**WILLIAM STATES LEE III
 NUCLEAR STATION UNITS 1 & 2**

Attachment 4

Revisions to FSAR Chapter 2, Subsection 2.5.5

FIGURE 2.5.4-244c

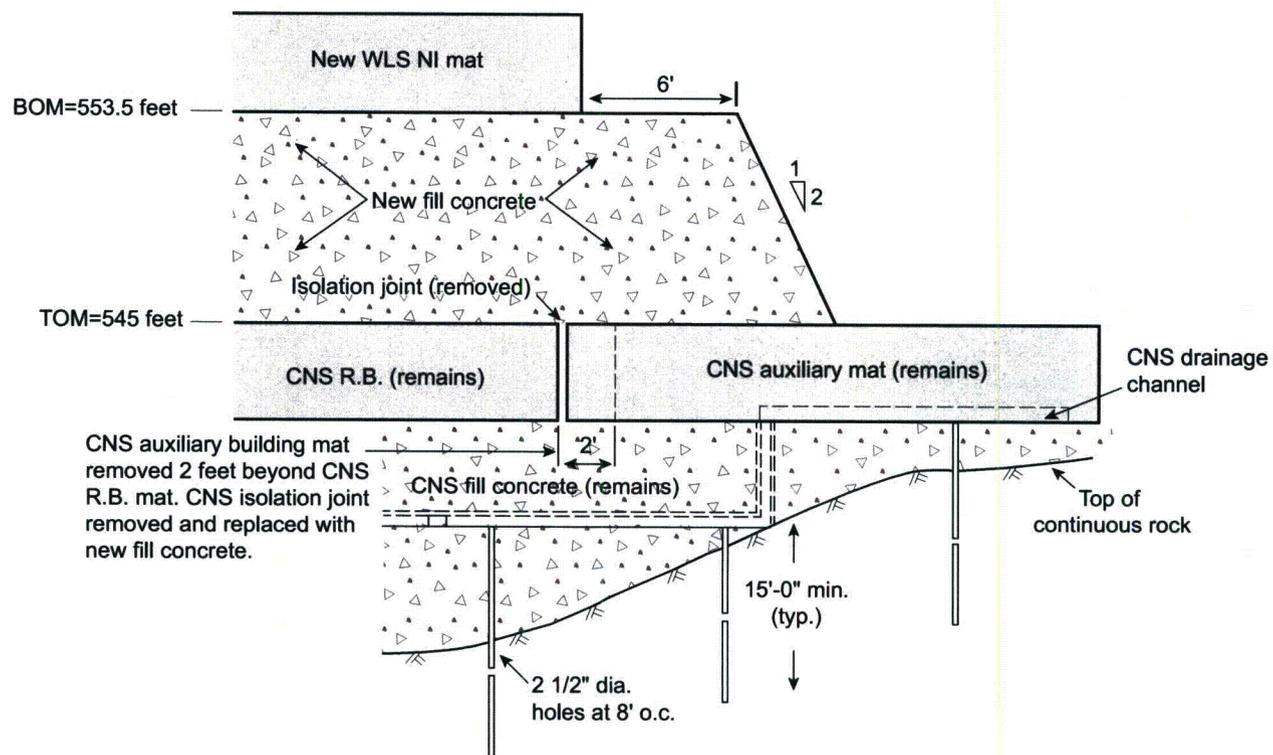
118. COLA Part 2, FSAR Chapter 2, Figure 2.5.4-244c is revised as follows:

FIGURE 2.5.4-244d

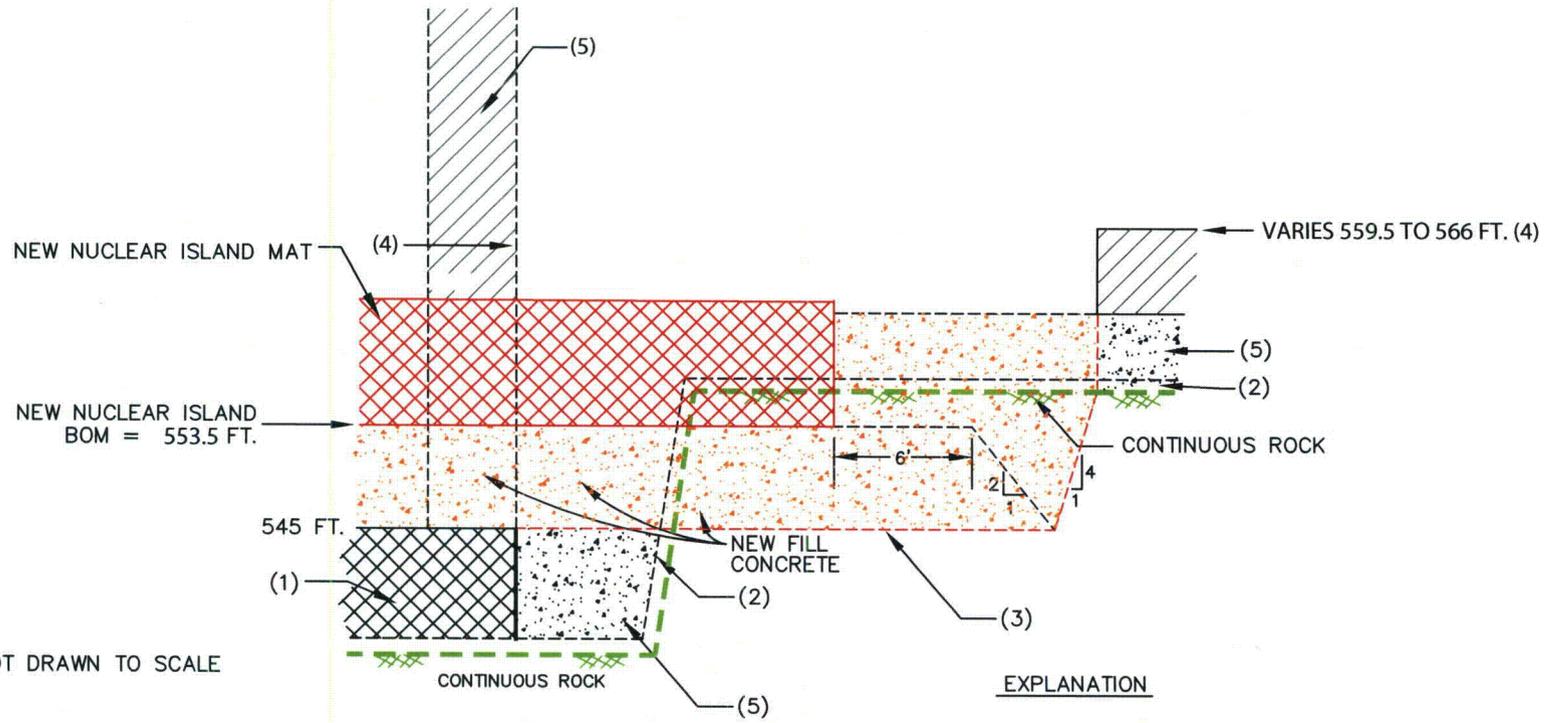
119. COLA Part 2, FSAR Chapter 2, Figure 2.5.4-244d is revised as follows:

FIGURE 2.5.4-248

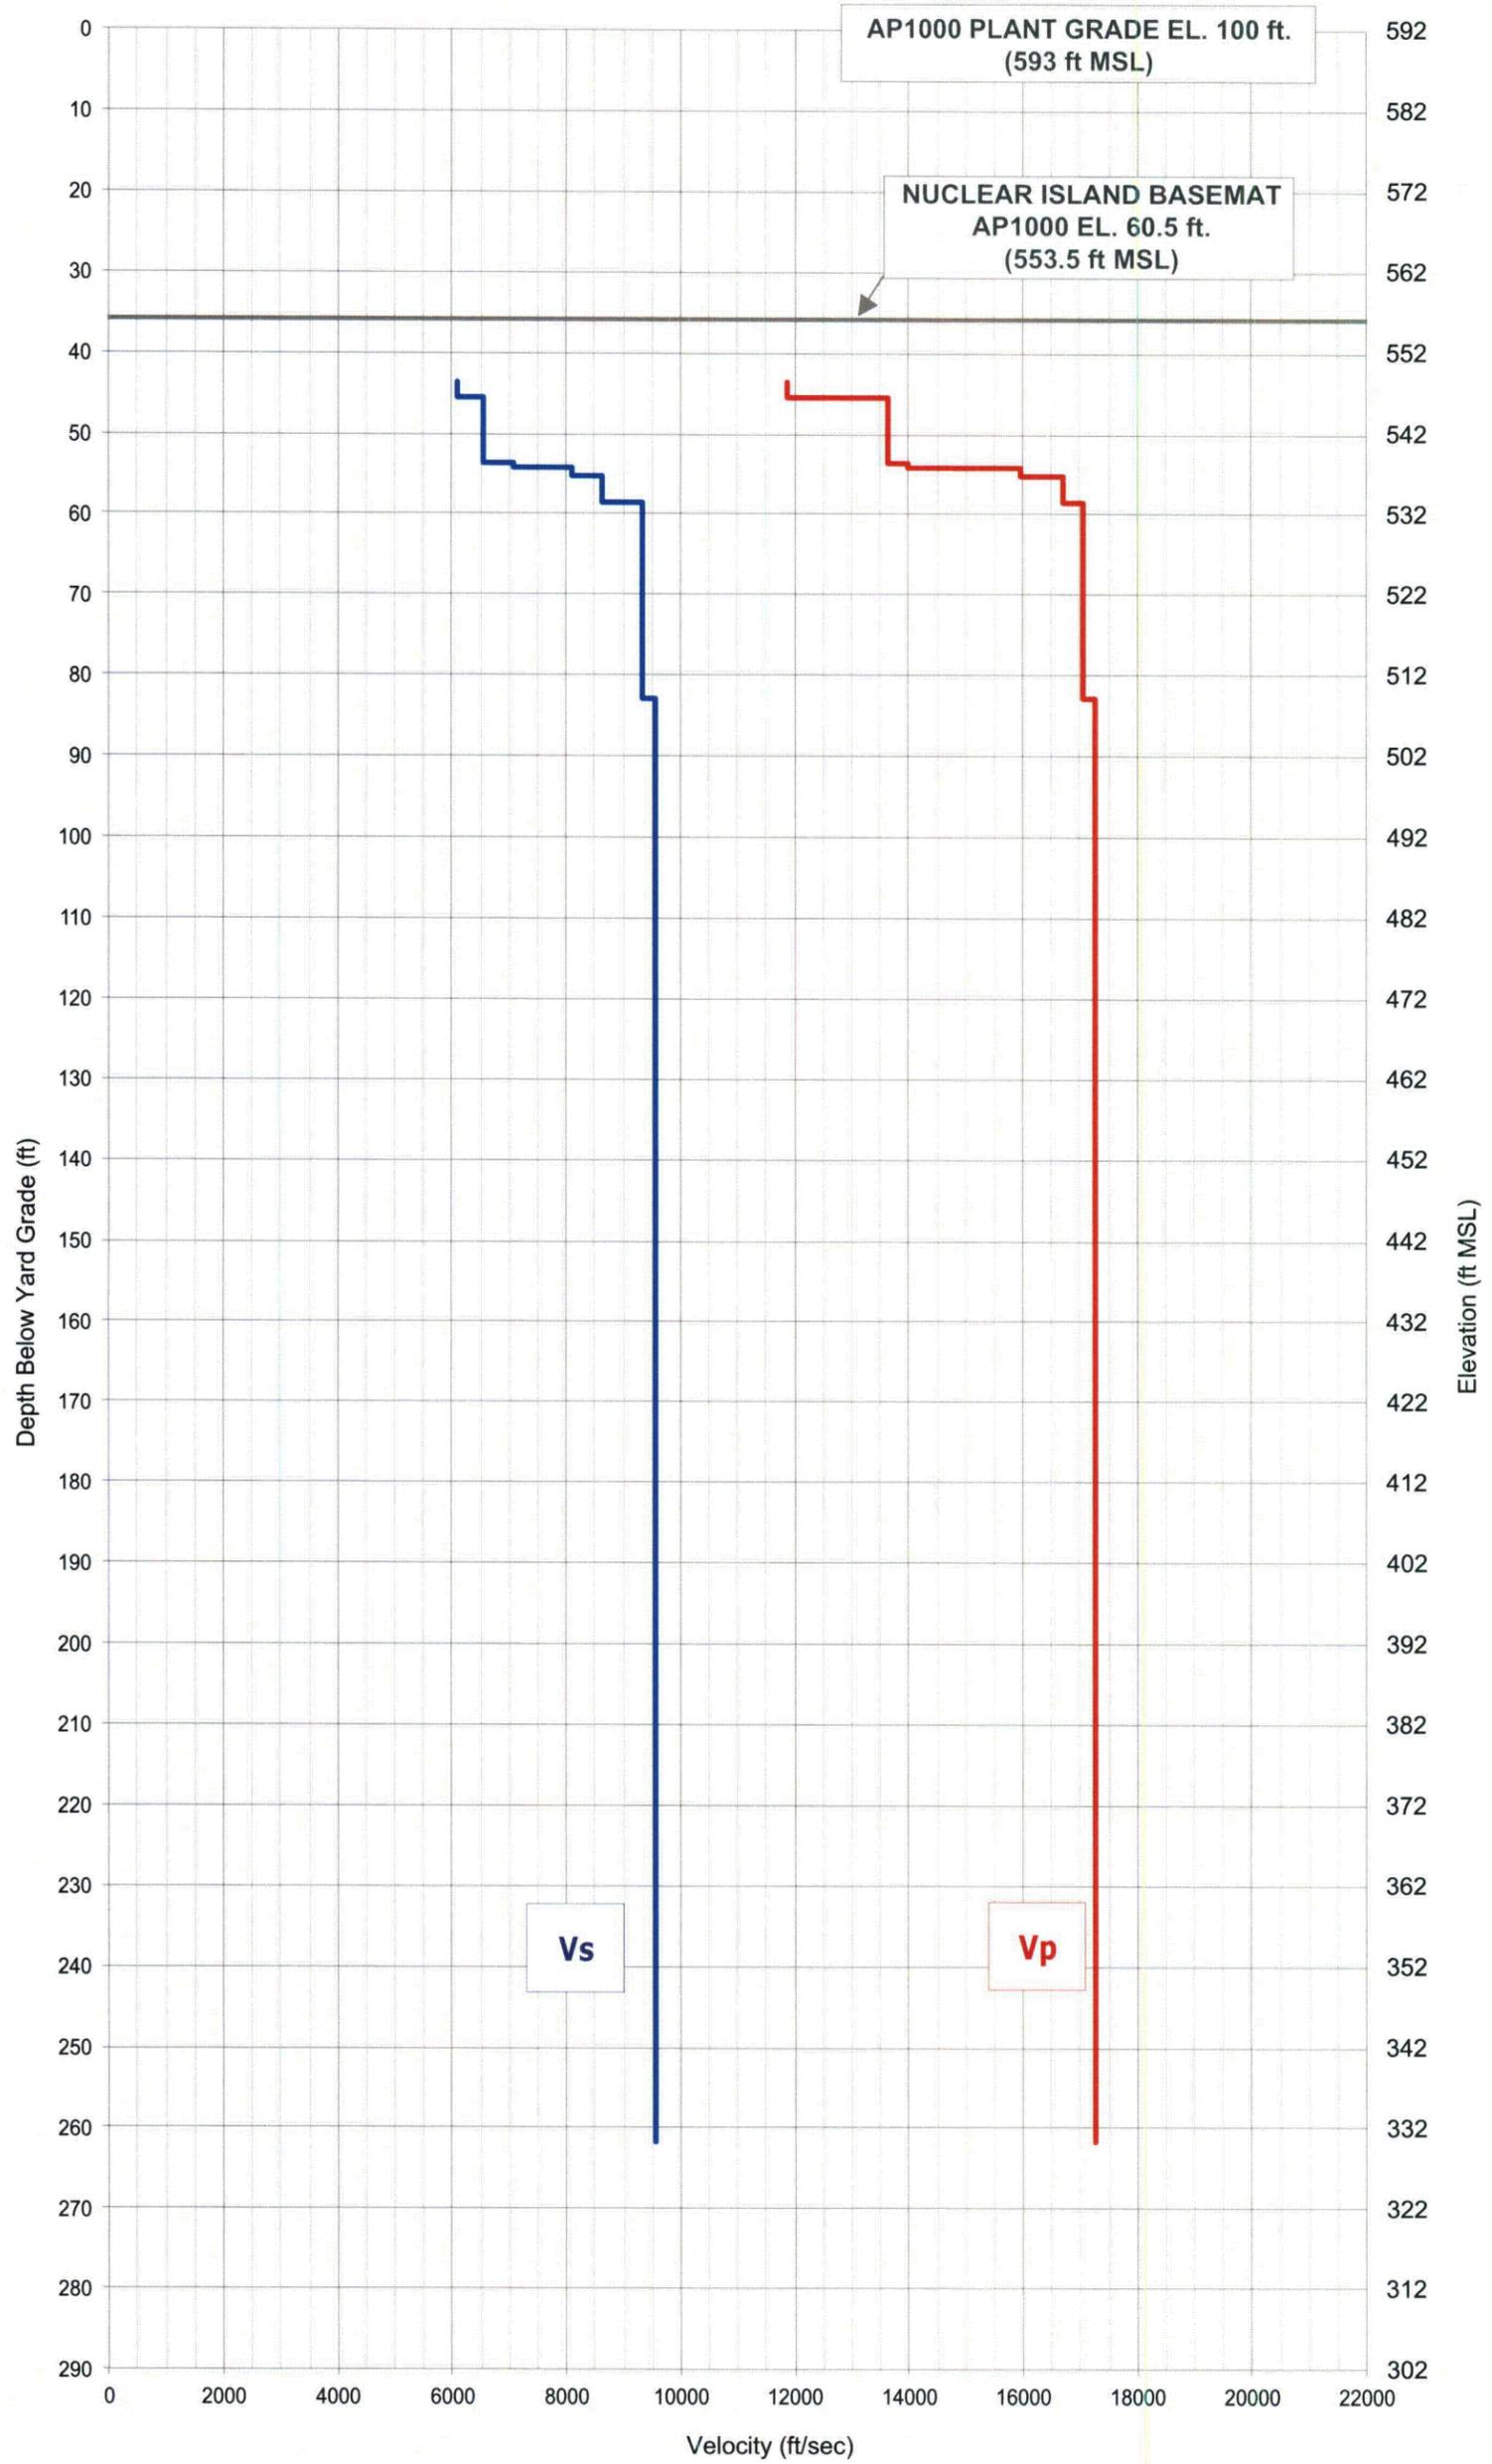
124. COLA Part 2, FSAR Chapter 2, Figure 2.5.4-248 is revised as follows:

FIGURE 2.5.4-250

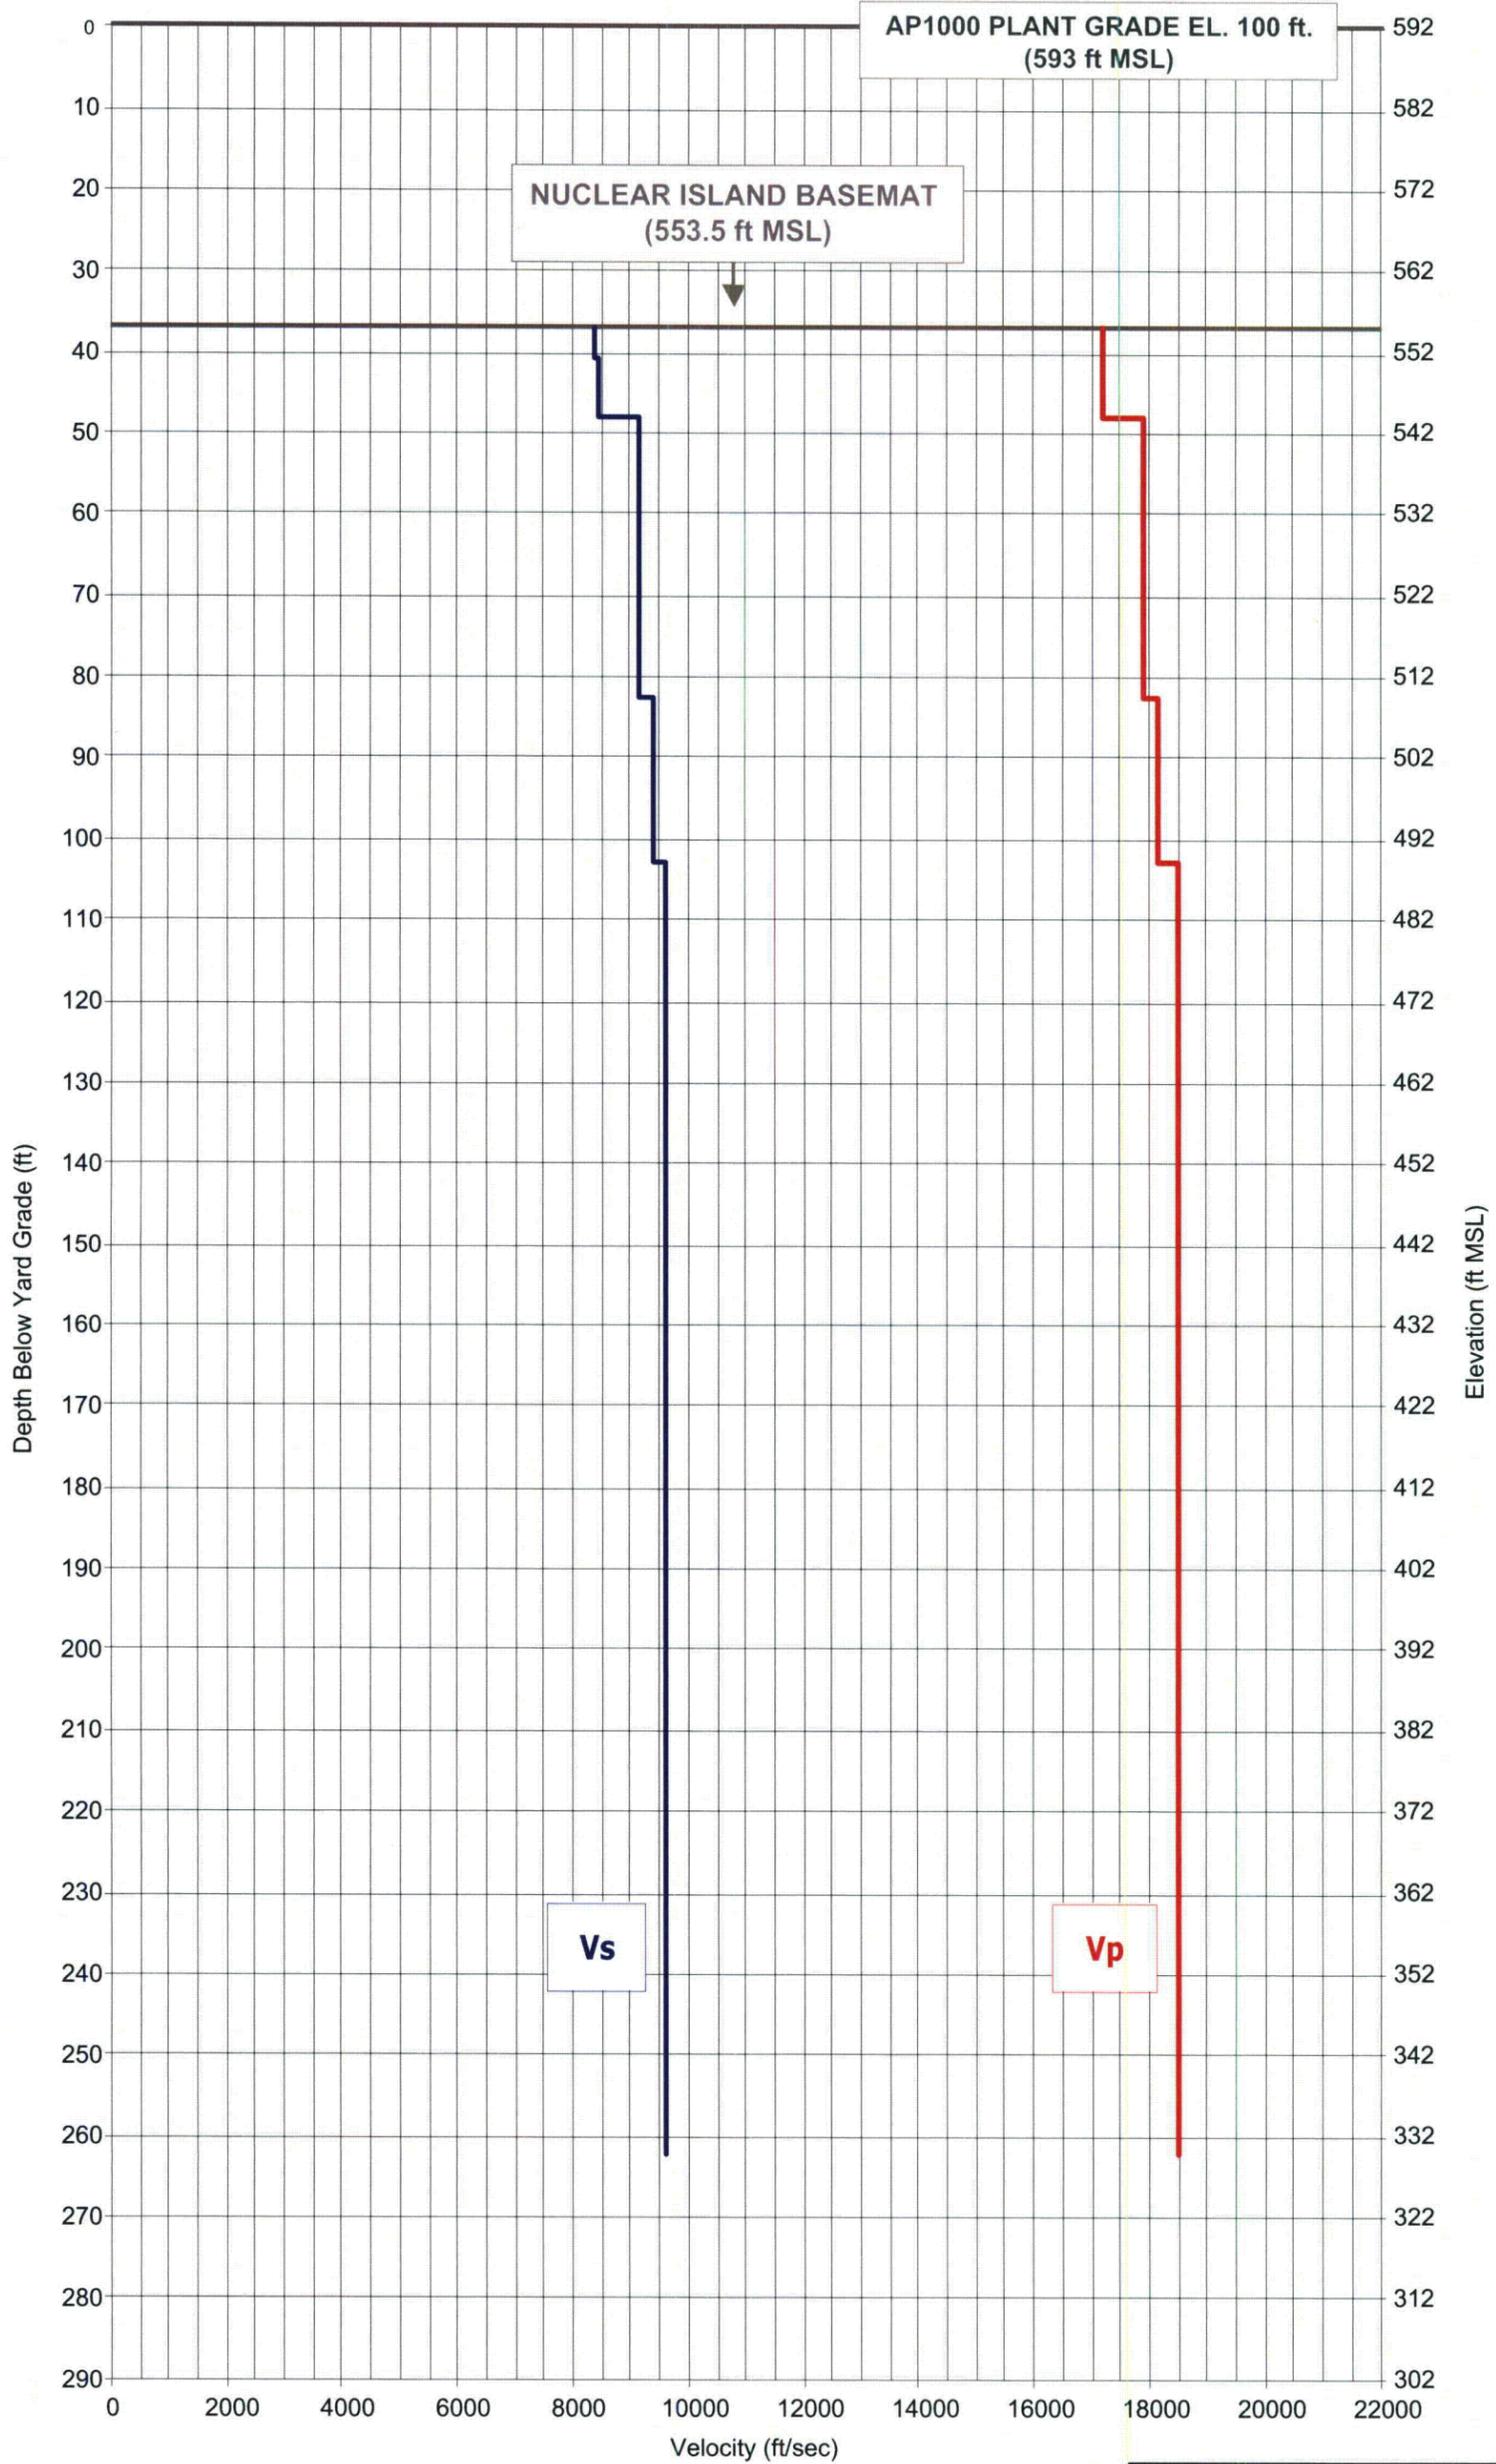
126. COLA Part 2, FSAR Chapter 2, Figure 2.5.4-250 is revised as follows:
